**PLANNED UNIT DEVELOPMENT
& SUBDIVISION STAFF REPORT****Date: May 20, 2010****DEVELOPMENT NAME**

Next Chapter Hillcrest

Next Chapter Hillcrest Subdivision

LOCATION208 Hillcrest Road
(West side of Hillcrest Road, 260'± South of Cedar Bend Court)**CITY COUNCIL****DISTRICT**

SITE PLAN

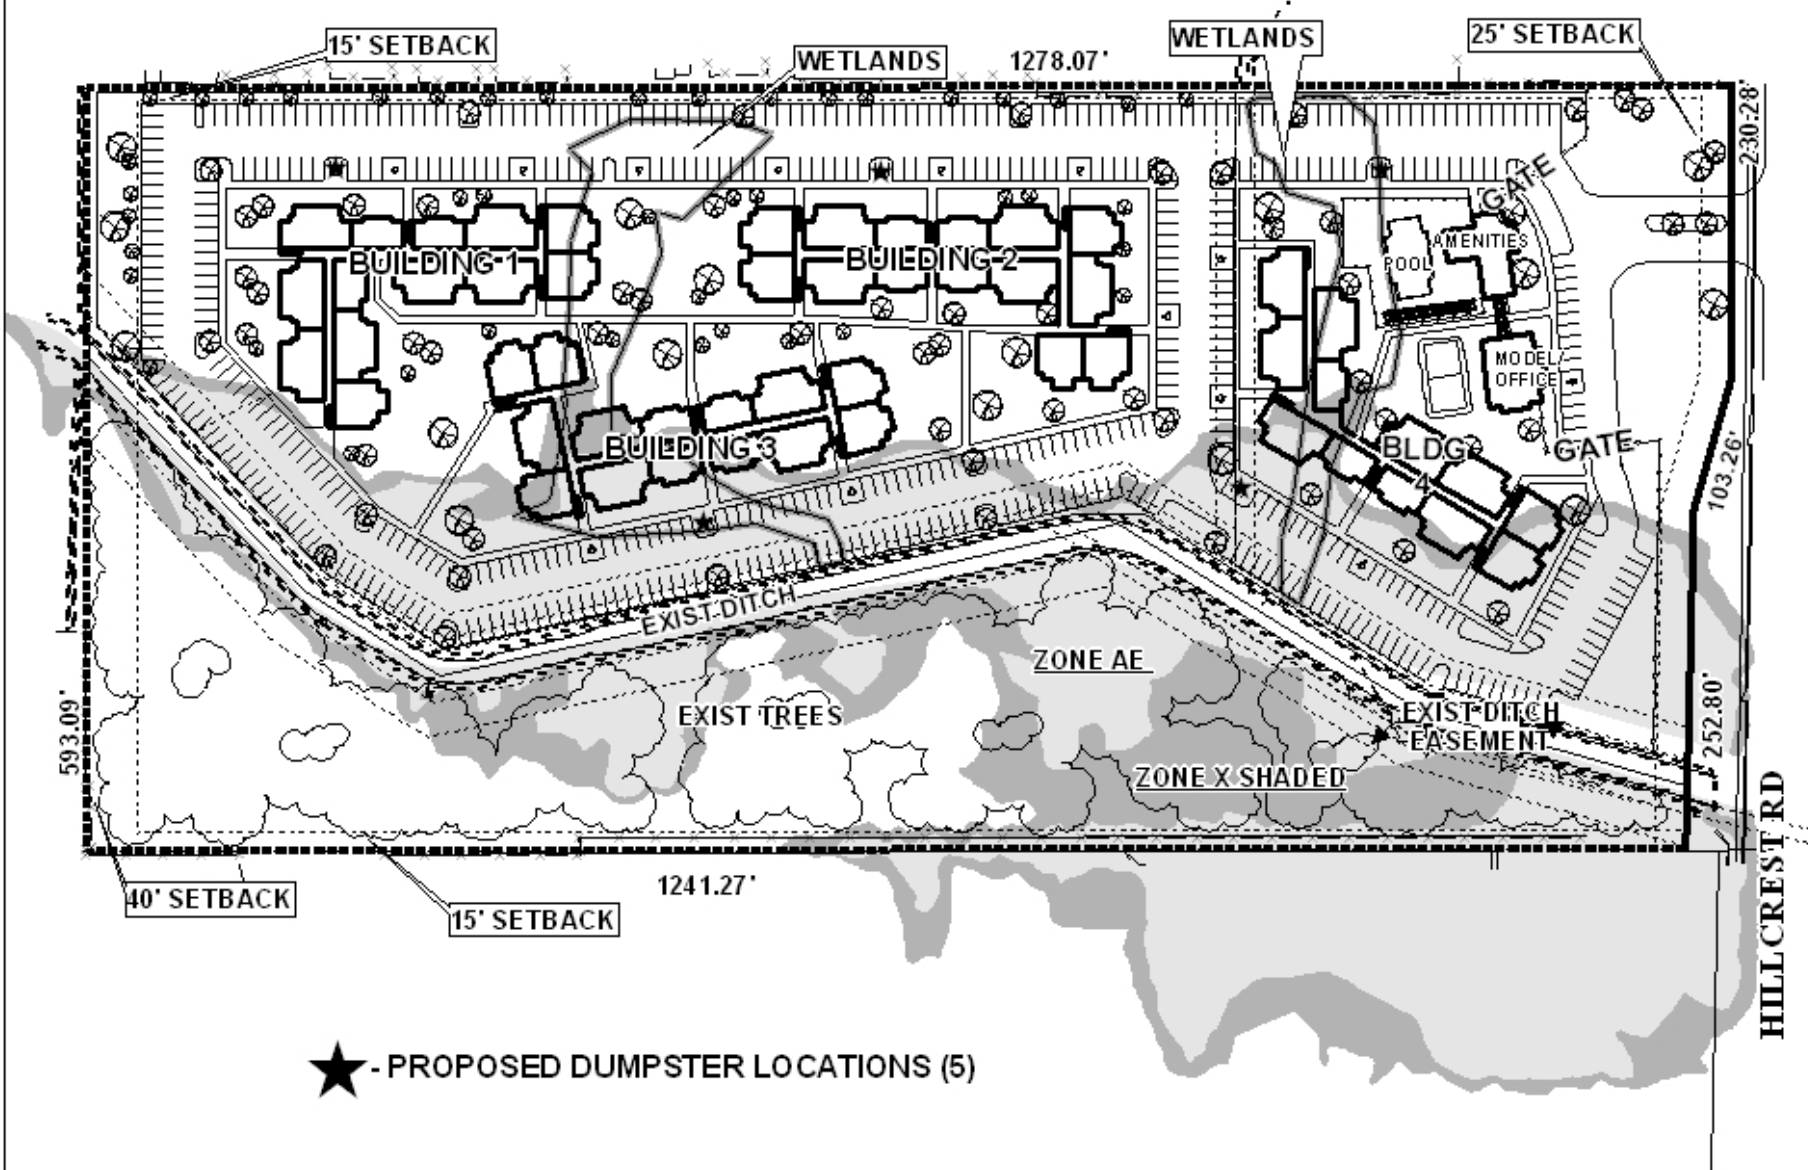
Currently, the proposed site plan depicts the entrance approximately 90 feet South of the Northern property line. To accomplish alignment with the existing apartment complex across Hillcrest Road, the entrance should be relocated South to approximately 230 feet South of the Northern property line.

The site plan depicts a fence and gates on the East side of the development fronting Hillcrest Road. Adequate queuing space existing for vehicle stacking at the proposed gates, and, if realignment is required, adequate queuing space of at least 51 feet should be maintained. No information is given regarding the type of fence is proposed. Part of the fence is proposed to be within the 25-foot front setback. If the fence is determined by the Planning Section to obstruct line of sight, the fence must be moved behind the setback line or can be no higher than 3 feet in height.

Five dumpsters are depicted on the site plan. The dumpster enclosures are depicted as being placed on peninsulas that jut into the parking area opposite landscaped peninsulas of the same size. This would reduce the maneuvering area for the dumpsters to 24-feet. Given that commercial dumpster garbage trucks pick up the dumpsters on their front-ends, it would appear that the location of the dumpsters may present maneuvering problems for the garbage trucks.

The site plan should be revised to depict the dumpster locations with adequate area for the trucks to maneuver.

Regarding the realignment of the curb cut, topographical concerns, as shown on the revised PUD site plan, indicate the aligning the curb cut for the site to the curb cut for the apartment complex directly across Hillcrest Road may be impractical. As such, the applicant has depicted the curb cut being moved to the North approximately 25 feet to further distance the curb cut from the curb cuts across Hillcrest Road. Traffic Engineering has indicated that this will be acceptable.

The proposed fence has been moved and now complies with the 25-foot front setback requirement. It should be noted that the applicant's have maintained an appropriate amount of queuing space for vehicles waiting to enter the fenced area.

Regarding the buffering requirements, no note was placed on the revised site plan indicating that the existing vegetation on the Western property line, South of Twelve Mile Creek would be maintained. If the vegetation is not maintained in compliance with Section 64-4.D.1. of the Zoning Ordinance, then construction of a compliant buffer would be required in this area.

The applicant has placed a notation on the site plan stating that the dumpsters will be for "side-loading trash vehicles." A further note indicates that the refuse will be "provided by a local company" and that there will be a "3-5 yard requirement." It is assumed that this means that each dumpster will need to be 3-5 cubic yards in volume. A brief survey of companies providing commercial garbage pickup revealed that these types of side loading dumpsters are not available in the Mobile area. As such, front-loading equipment would have to be used, and the site design is not adequate for maneuvering of front-loading garbage trucks. Because of this, unless the applicant can provide documentation that side-loading equipment and service is available for 3-5 cubic yard dumpsters in the City of Mobile, the applicant will need to rearrange the site layout to account for appropriate maneuvering area for front-loading garbage trucks.

- 1) realignment of the curb cut to line-up with the curb cut for the existing apartment complex directly across Hillcrest Road from the site;
- 2) if it is determined by the Planning Section that the fence obstructs height, realignment of the fence in the front of the property to behind the 25-foot minimum building setback line or notation on the site plan stating that the fence will be no higher than 3 feet in height;

- 3) if realignment of the fence is necessary, maintaining of at least 51 feet of vehicle queuing space at the entrance gates;
- 4) revision of the site plan to depict the dumpster locations with adequate area for the garbage trucks to maneuver;

- 1) completion of the rezoning process;
- 2) placement of a note on the site plan stating that the existing vegetation on the Western property line, South of Twelve Mile Creek will be maintained in compliance with Section 64-4.D.1. of the Zoning Ordinance, or an appropriate buffer be indicated on the site plan;

- 3) revision of the site plan to depict the dumpster locations with adequate area for front-loading garbage trucks to maneuver or provision of documentation that side-loading equipment and service is available for 3-5 cubic yard dumpsters in the City of Mobile;
